Appendix A – Mitigation Monitoring and Reporting Program and Project Design Elements

Trinity River Channel Rehabilitation Sites: Lower Steiner Flat (River Mile 90.2-91.3) and Upper Junction City (River Mile 79.8-80.4)

May 2012

SUBJECT: Comment Letter on Upper Junction City Rehab Project Re: Depper Property

Figures 2. Simulated and measured bank erosion at UJC-B for the period 2009-2011.

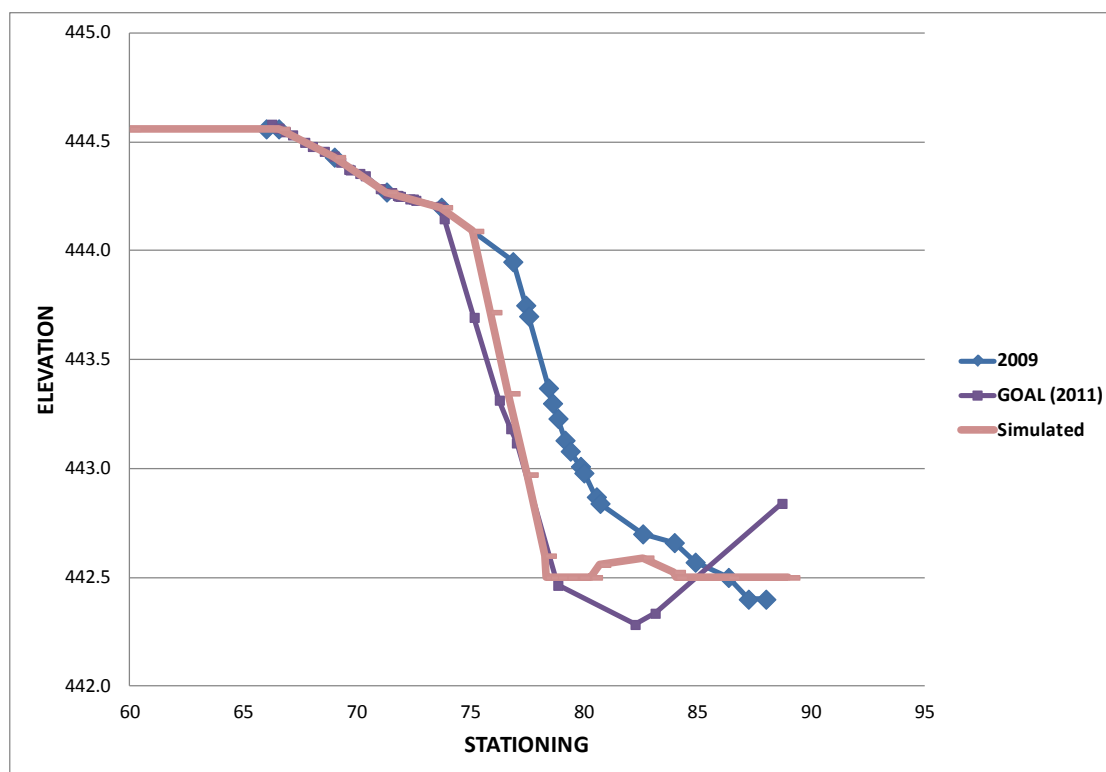
property. To avoid the need for compensation preliminary management recommendations should be developed to avoid bank erosion. Need a detailed analysis to determine placement of instream structures to protect the bank.	conducted of design versus no action (existing) erosion conditions. Results demonstrate that changes in hydraulics due to the planned construction of habitat enhancement features will have little, if any affect on bank-erosion rates along the left bank. See “ <i>Response to Comments Regarding Bank-Stability Issues</i> ” from Cardno Entrix (Dr. Andrew Simon) following this table. Additional analysis of hydraulic model output demonstrates that construction of the project will reduce shear stresses and erosion rates along the right bank adjacent to the Depper property. See the response “ <i>Pertaining to the Right Bank at UJC</i> ” written by the TRRP’s Dr. David Gaeuman following this table.

The total amount of bank erosion simulated at UJC-B for the 2009-2011 period under existing hydraulic conditions (scenario #1) was 3.8 m² and closely matches the measured changes in geometry (Figure 2). To obtain satisfactory calibration results, a drawdown of 0.5 m was assumed on the recessional limb of the hydrograph. Hydraulic erosion accounted for 2.5 m² while mass wasting accounted for the remaining 1.3 m². Following this successful calibration, the model was re-run with the measured 2011 bank section as the initial geometry.

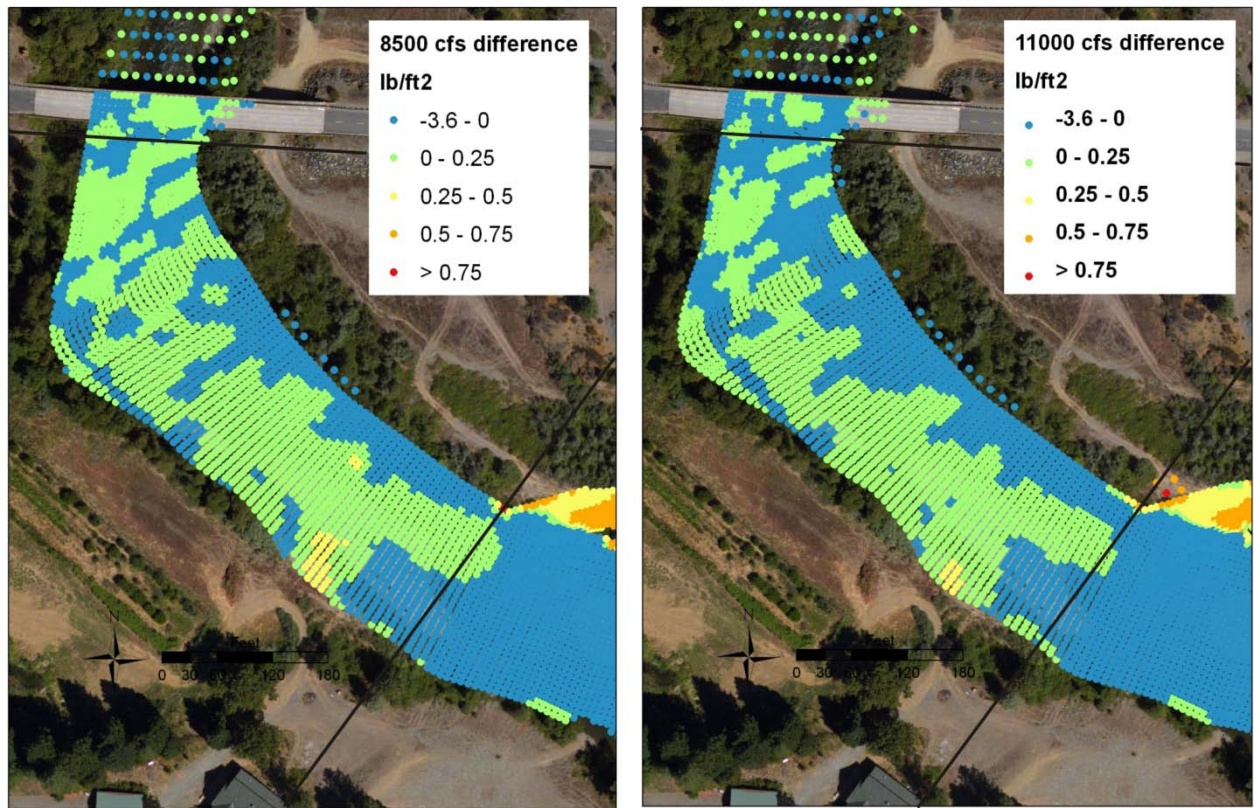
A letter from Franklin Goldman dated April 13, 2012 raised the question of whether the proposed construction at the Upper Junction City (UJC) rehabilitation site would result in increased bank erosion rates along Mr. Depper's property. Analyses performed by Dr. Andrew Simon using the BSTEM bank erosion model indicate that the project is have little effect on erosion rates along the left bank adjacent to the Depper property. Those results are discussed in a separate attachment submitted by Dr. Simon. However, Mr. Goldman has also inquired about modeling and analysis relevant to potential changes in the erosion rate along the right bank. That issue is addressed here.

SRH-2D output showing the changes in shear stresses that are expected to result from construction of the UJC project when discharges are 8500 and 11000 ft³/s is shown in Figure 1. The Figures show that the model indicates that construction of the UJC project will result in a decrease in shear stresses along nearly the entire length of right bank through the Depper property at both discharge levels. Local increases in shear stress are indicated in a few small areas, but the magnitude of the increase is small. Overall, the model indicates that construction of the UJC project will either have no effect on the potential for bank erosion along the right bank adjacent to the Depper property or will reduce the potential for erosion.
